Request for Additional Information for EMC Certification

Company:	ZTE Corporation	Composite Device:	Yes: <input type="checkbox"/>	No: <input checked="" type="checkbox"/>
MT#:	27236	FCC Direct Filing:	Yes: <input type="checkbox"/>	No: <input checked="" type="checkbox"/>
		Permit But Ask:	Yes: <input type="checkbox"/>	No: <input checked="" type="checkbox"/>
FCC ID:	Q78-ZTEMF110	FCC Rule Part:	22H/24E; 15B	
UPN:	N/A	RSS Standard:	N/A	
FRN:	0009043175	Class II PC/Reassessment:	Yes: <input type="checkbox"/>	No: <input checked="" type="checkbox"/>

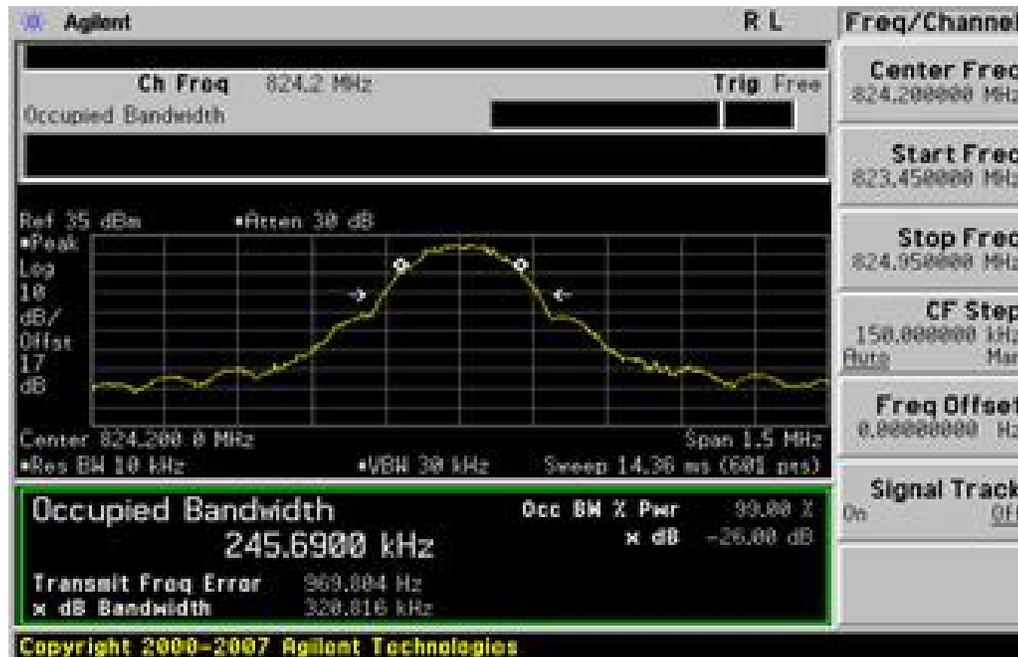
5. FYI, in ER-2009-20013_Part 22H+24E Report.pdf, the Occupied Bandwidth tables list the 99% Bandwidth. The -26 dBc bandwidth is not the 99% bandwidth; in fact, it is the 99.5% bandwidth. Since the -26 dBc values are given on the plots, these bandwidth values will be used for the emissions designator.

Test equipment can test 99% bandwidth and -26dB Values. Please see the following figure.
